Re: 176 Scraggy Neck Road, Bourne, MA

I have reviewed the revised site plans (August 22, 2022) and associated documents, and other relevant data and resources published by the Cape Cod Commission, Massachusetts Department of Environmental Protection (MADEP), Massachusetts Coastal Zone Management (MACZM), Massachusetts Geographic Information System (MAGIS), United States Geological Survey (USGS), USDA Natural Resources Conservation Service (NRCS), the Federal Emergency and Management Agency (FEMA) and United States Environmental Protection Agency (USEPA).

Figure 2 - Site Plan with 50-foot Setbacks and Potential Allowable Building Envelope

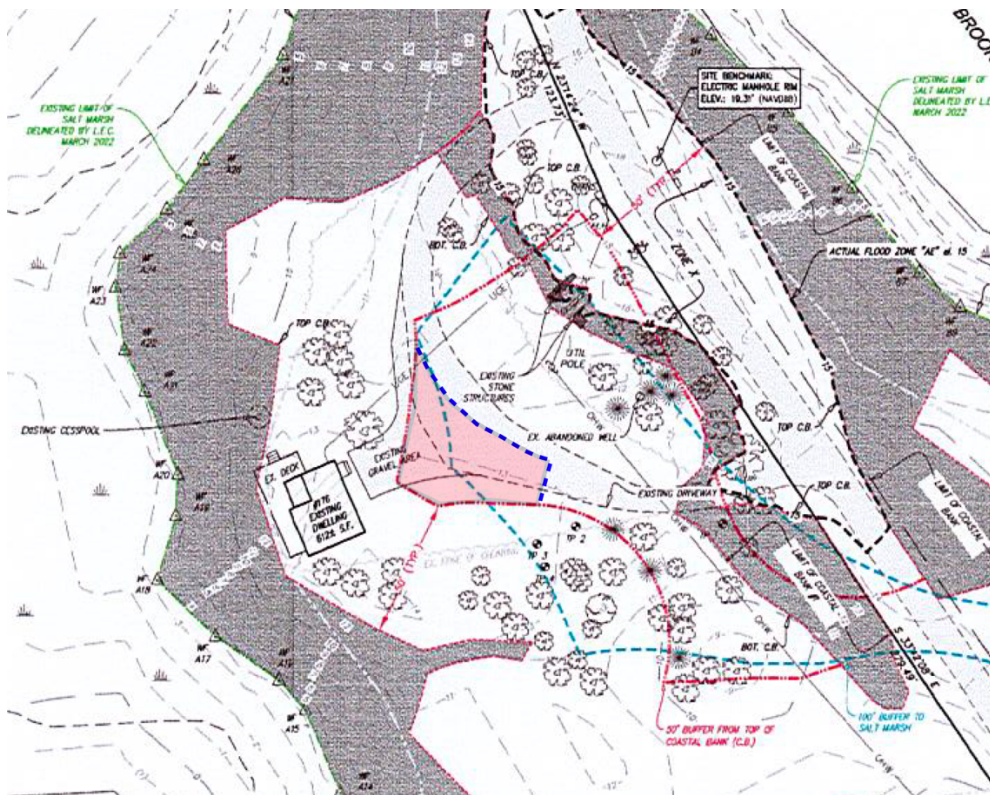
**1. The site plans omit some of the applicable buffer zones and setbacks from the coastal bank.** The site plans prepared by Bracken Engineering, Inc. show three coastal banks on the subject property. However, the plans only show the “50-foot coastal bank buffer” areas for two of the coastal banks. Although the plans identify “coastal bank #2” on the property, there is no corresponding “50-foot coastal bank buffer” for this coastal bank.

**2. The applicant refers to a portion of the coastal banks as a “secondary coastal bank”.** The application submittal by LEC dated August 24, 2022 and the attached letter from ECR (Stan Humphries) dated August 19, 2022 refers to a portion of the coastal bank as a “secondary coastal bank”. I am not aware of any such designation or distinction anywhere in the MA Wetlands Protection Regulations or the Bourne Wetlands Bylaw. Coastal bank#2 is a jurisdictional wetland Resource Area, with the same setbacks and buffer zones provided in the applicable regulations as the other coastal banks on the property.

**3. The Bourne Wetlands Bylaw requires a 50-foot setback from coastal banks** and states, “no habitable dwelling or accessories thereto or roadway / driveway shall be allowed any closer than 50-feet from the boundary of a Wetland Resource Area unless permitted under this bylaw” (Section 3.7.4). I have added the missing 50-foot setback (dark blue dashed line) from coastal bank #2 (see figure 2). My analysis suggests that there might be a smaller allowable building envelope within the project site (see pink highlighted area) that is outside of the 50-foot setback for all the coastal bank resource areas, in compliance with the requirements in the Bourne Wetlands Bylaw.
